Service Information
No. SI-E4-011

Global alternative means of compliance (AMOC) to FAA AD 2018-07-16 (g)

MANDATORY SERVICE BULLETIN

No. MSB-E4-022/5
SUPERSEDES MSB-E4-022/4

Figure 4: Waste Gate Circlip

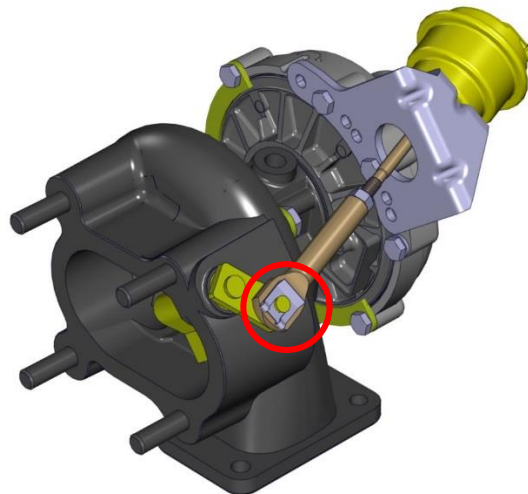
1. Make sure MM-TR-MDC-E4-386 and MM-TR-MDC-E4-399 are inserted into the Maintenance Manual or a revision of the Maintenance Manual with the Temporary Revisions incorporated is used.
2. Replace the waste gate controller according to Maintenance Manual section 81-00-33.
3. Install a new the spring loaded circlip E4A-41-100-801. Refer to figure 4

1. Replace the waste gate controller according to Maintenance Manual section 81-00-33.
2. Install a new the spring loaded circlip E4A-41-100-801. Refer to figure 4.

Figure 5: Fire sensor bracket shims

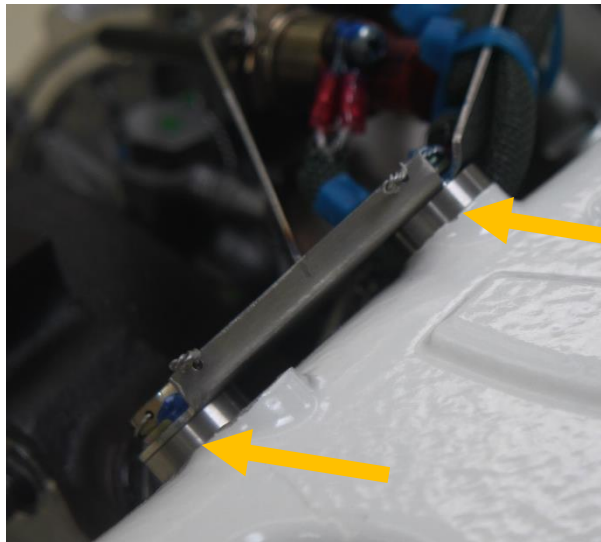
3. Install the waste-gate con-rod fail-safe bridge according to Maintenance Manual section 81-00-36 or install a waste-gate controller with the fail-safe con-rod bridge already installed. Make sure there is sufficient clearance to adjacent parts.
4. For twin engine installations only: If there is insufficient clearance between the waste-gate con-rod fail-safe bridge and the fire sensor bracket, shim between the fire sensor bracket and the injector cover with bushings BU2-20-08-0050-C. Refer to Figure 5 and the Airplane Maintenance Manual for installation.
